# **ADDENDUM**

## **Trackstar Board Installation for Tandy 1000 TX**

**Note:** This addendum is used only for Tandy 1000 TX users. Page 35 of the manual is replaced with this addendum for the Tandy 1000 TX.

Side View of the Tandy 1000 TX

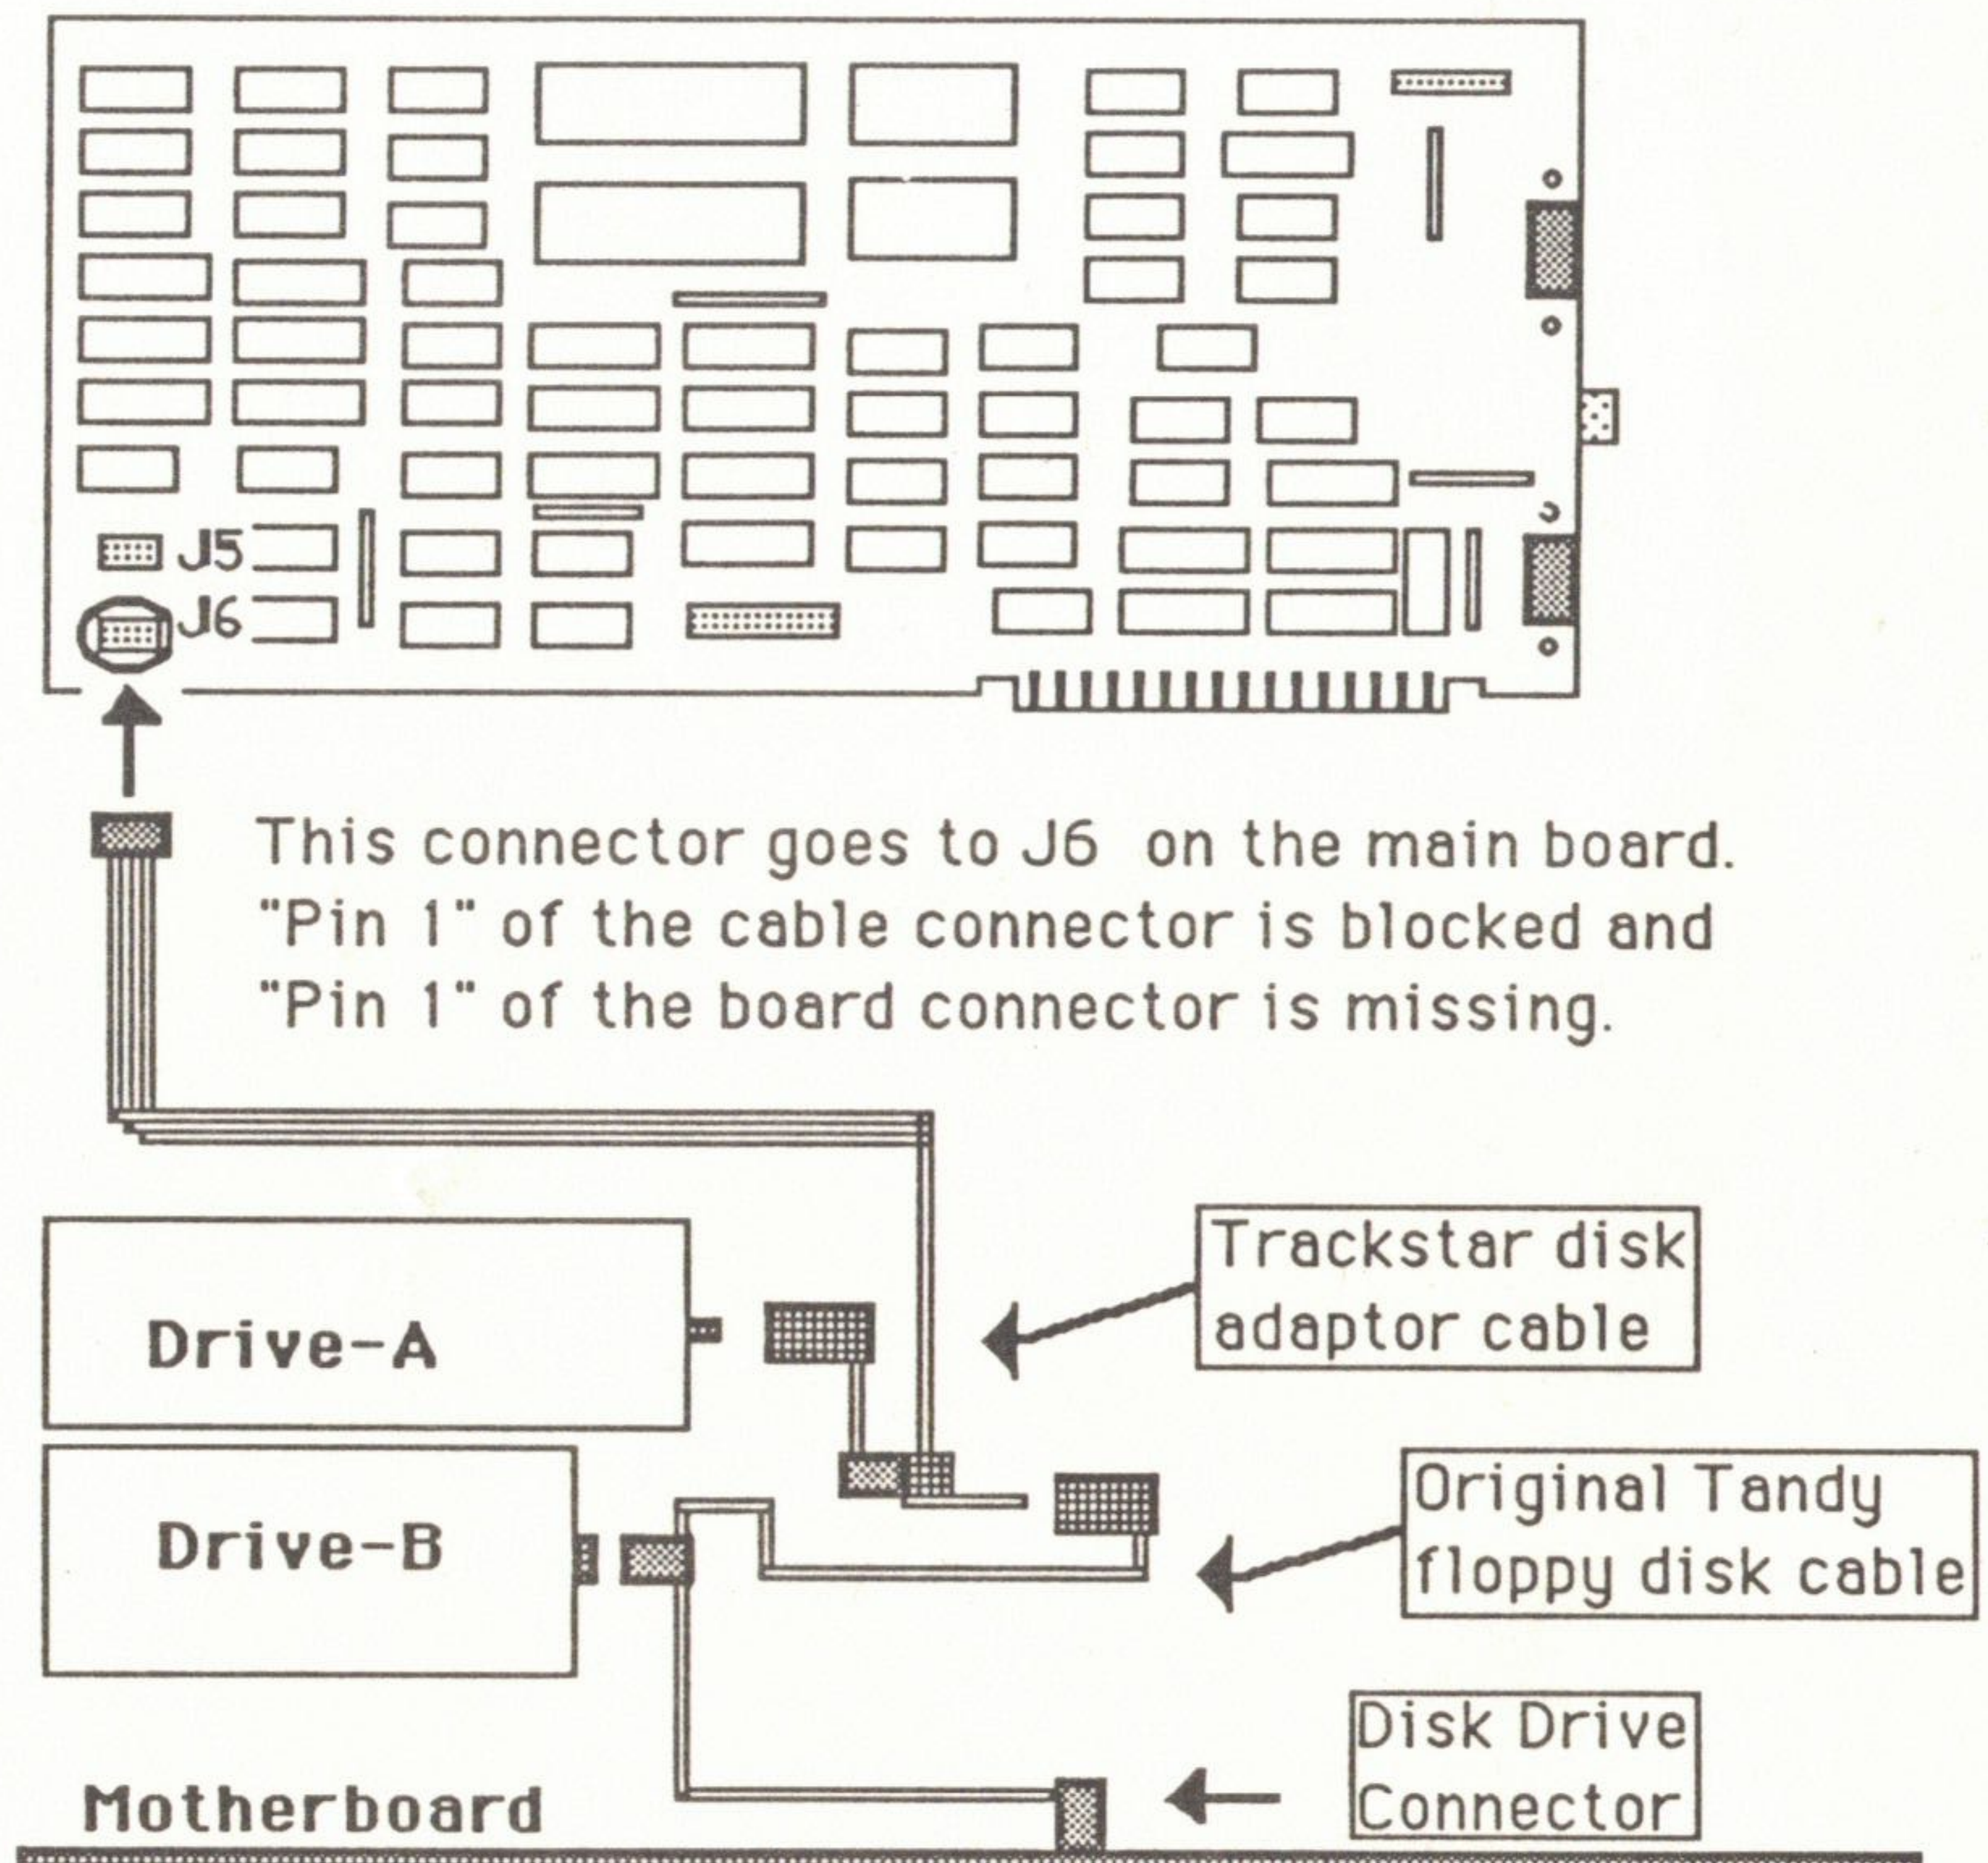
When the modification of the Trackstar disk adaptor cable is finished, the adaptor cable should be connected between the 5 1/4" disk drive and the original floppy disk cable as follows.

A capacitor should be installed in the drive if it is a TEAC 5 1/4" drive. (Refer to page 33 of the manual. Pins 4 and 5 are used for TEAC FD 55BR-521-U disk drive.)
